Planning Commission Staff Report

MEETING DATE: OCTOBER 7, 2020

SUBJECT: DR20-113, MERCEDES BENZ OF GILBERT PARKING LOT EXPANSION

SITE
PHOTOMETRIC
PLAN

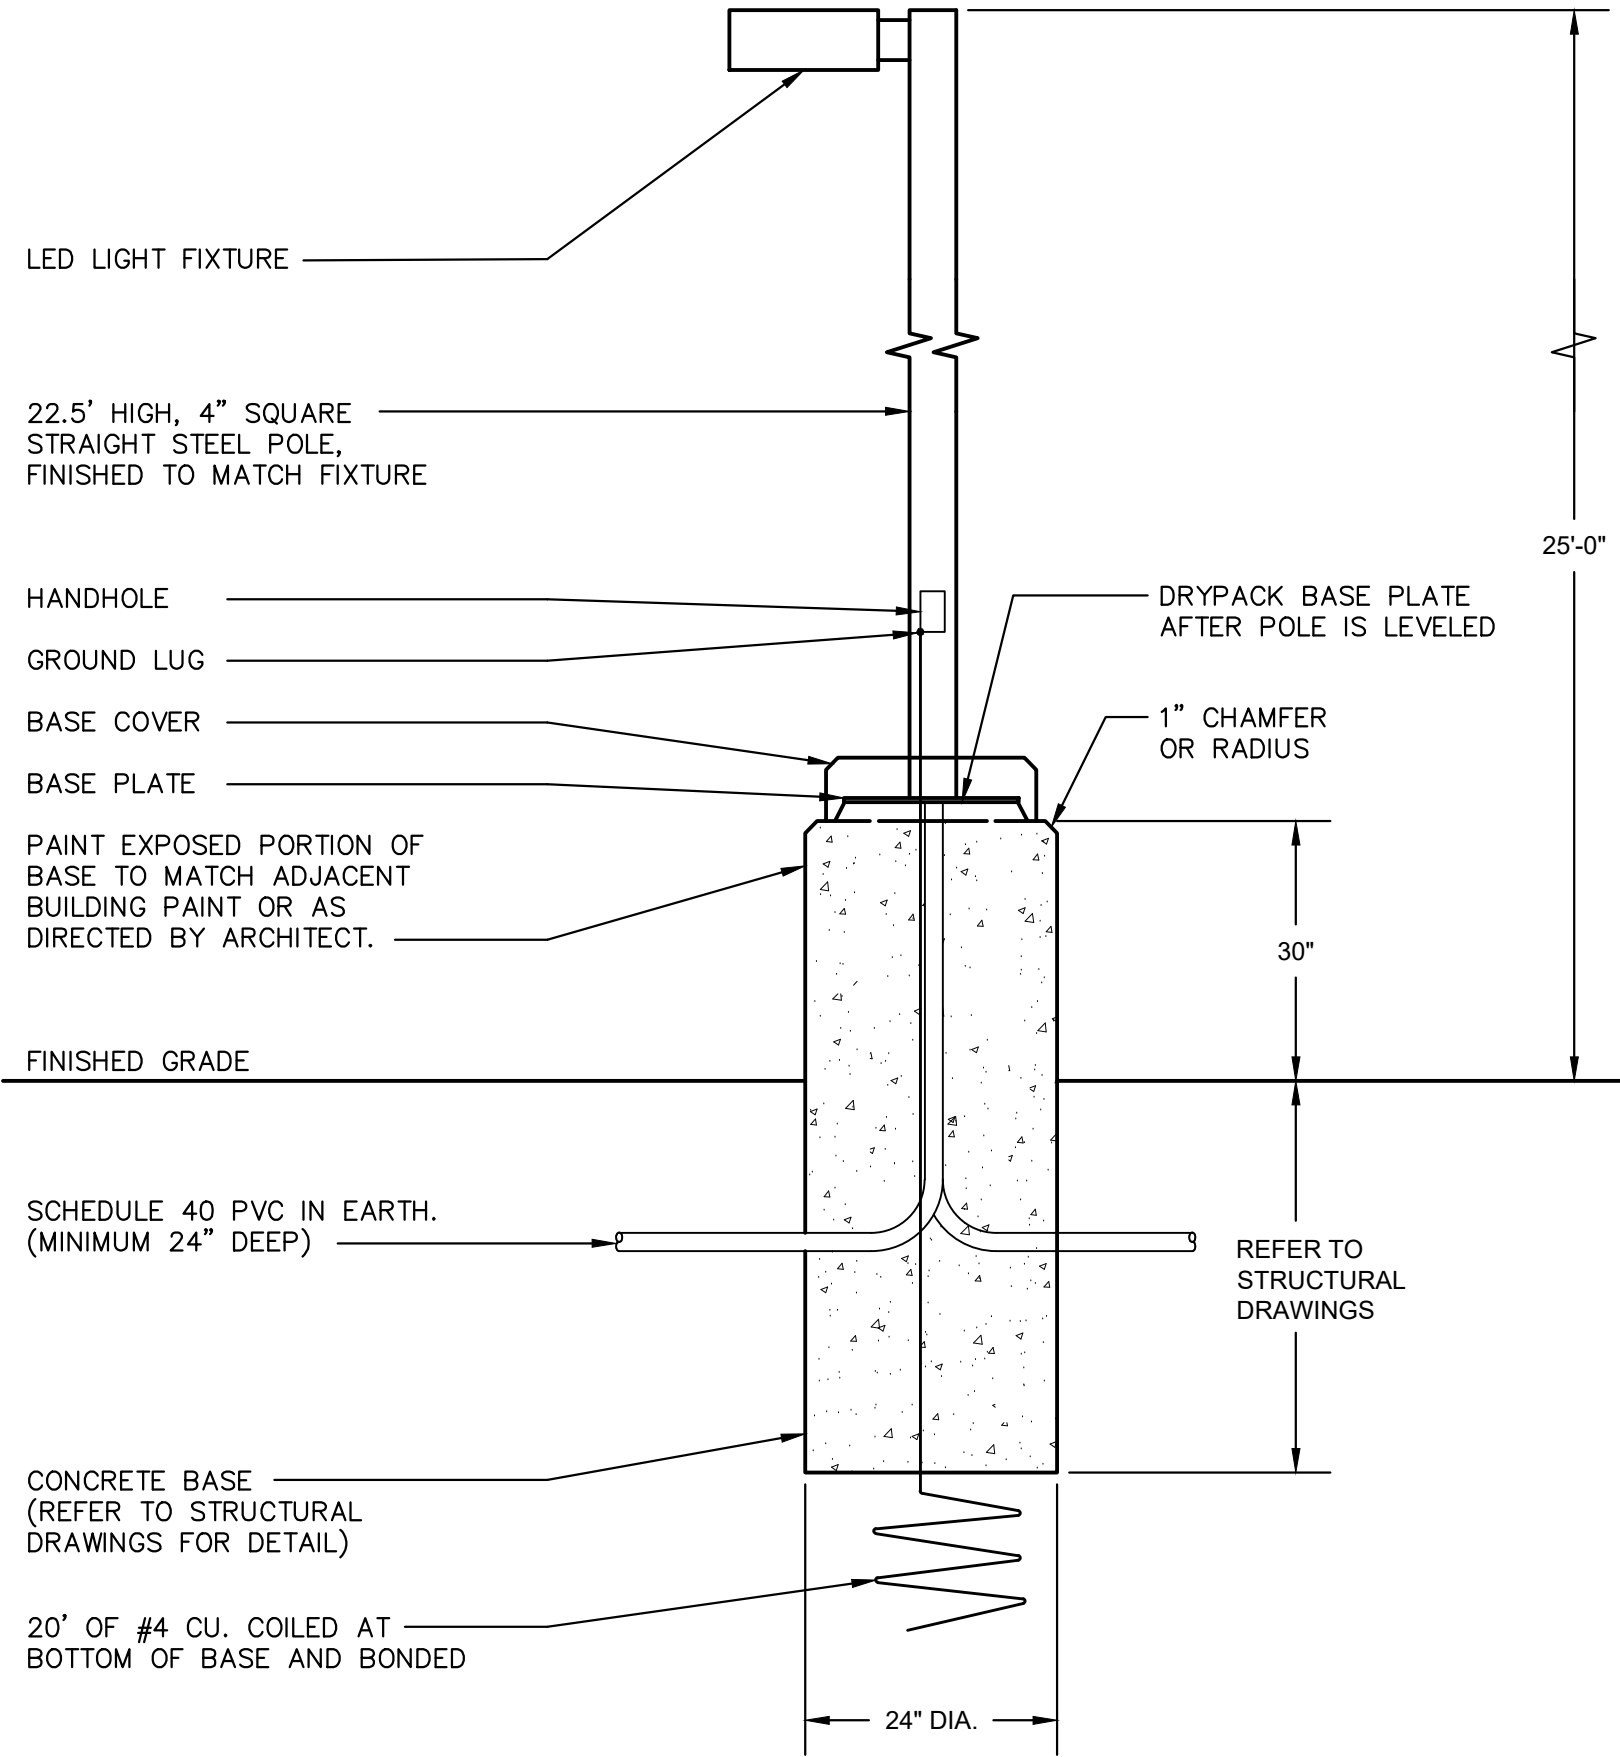
The only lighting proposed is parking lot lighting. The parking lot lights are proposed to be mounted at 15’ and 25’. The proposed lighting as shown exceeds the maximum footcandle allowed per Town Codes. As a condition of approval, staff will require that the applicant submit a modified photometric plan showing compliance with Town Codes.

- a. Construction of the project shall conform to the exhibits approved by the Planning Commission at the October 4, 2020 public hearing.
- b. The construction site plan documents shall incorporate the Standard Commercial and Industrial Site Plan Notes adopted by the Design Review Board on March 11, 2004.
- c. Signage is not included in this approval. All signage must comply with the Rivulon Master Sign Plan.
- d. Prior to issuance of a building permit the applicant shall submit to Planning and Development a revised photometric plan showing a reduction in the level of

illuminance at the property line, the level of illuminance shall not exceed 0.3 foot-candles.
